**Belmont Ridge Road Corridor Planning Study
Phase 1
Blue Ridge District**

**Public Comment Period
September 21, 2022 through October 5, 2022**

Summary of Public Comments & Questions Received with Responses

Figure 1 85th Percentile Vehicle Travel Speeds on Belmont Ridge Road

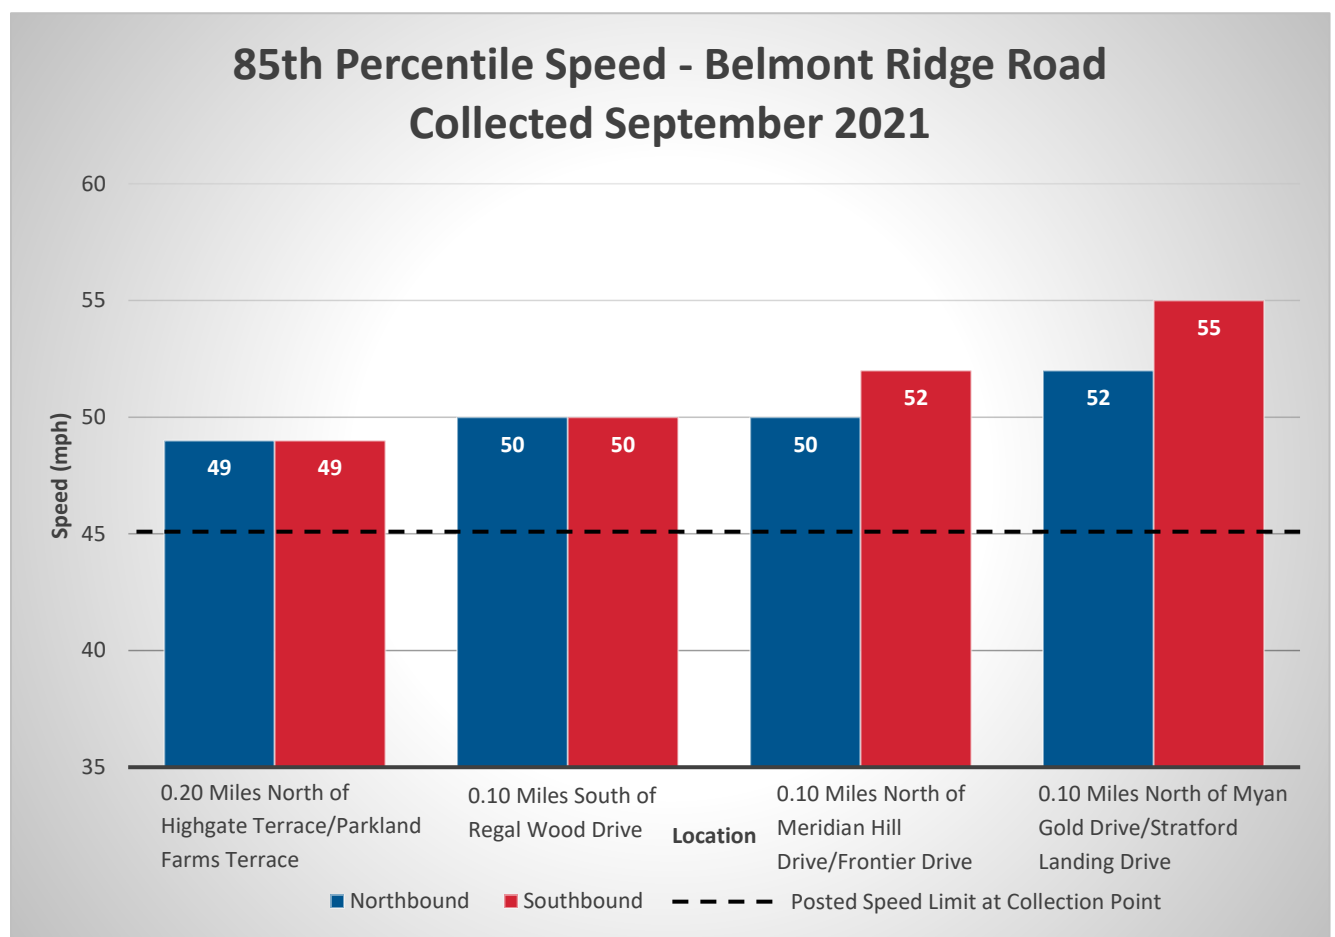
Q1. Thanks for the initiatives. I've two homes in Brambleton. Both are on Belmont ridge rd. I've few concerns: 1) Why 45 speed limit in residential road? Should be 35? 2) At Legacy park dr & Belmont ridge rd intersection it took 3-5 min to turn left turn and very scary to as the vehicle approaching at ~50 miles speed. Please focus on more improvement at that intersection. Thanks	
A1:	1) In the Adopted Loudoun County 2019 Countywide Transportation Plan, Belmont Ridge Road is classified as a Minor Collector. This roadway type serves to provide connections within communities. A residential road – or local road – is typically within neighborhoods where residences connect to the road via driveways. Information on how VDOT sets speed limits can be found https://www.virginiadot.org/info/faq-speedlimits.asp . More

Q27. Missing dates/times/durations used for speed limit measurement and truck volume- can it be clarified what times, durations the speed limit rates and truck volumes were measured? Was it measured at peak volumes?

A27: Speed data was collected for continuous 24-hour periods during all times of day (including peak volumes) over a three day period from September 21 – 23, 2021. This is the same time period and dates during which traffic volumes and truck volumes were measured.

Figure 1 summarizes the 85th percentile vehicle travel speeds on Belmont Ridge Road.
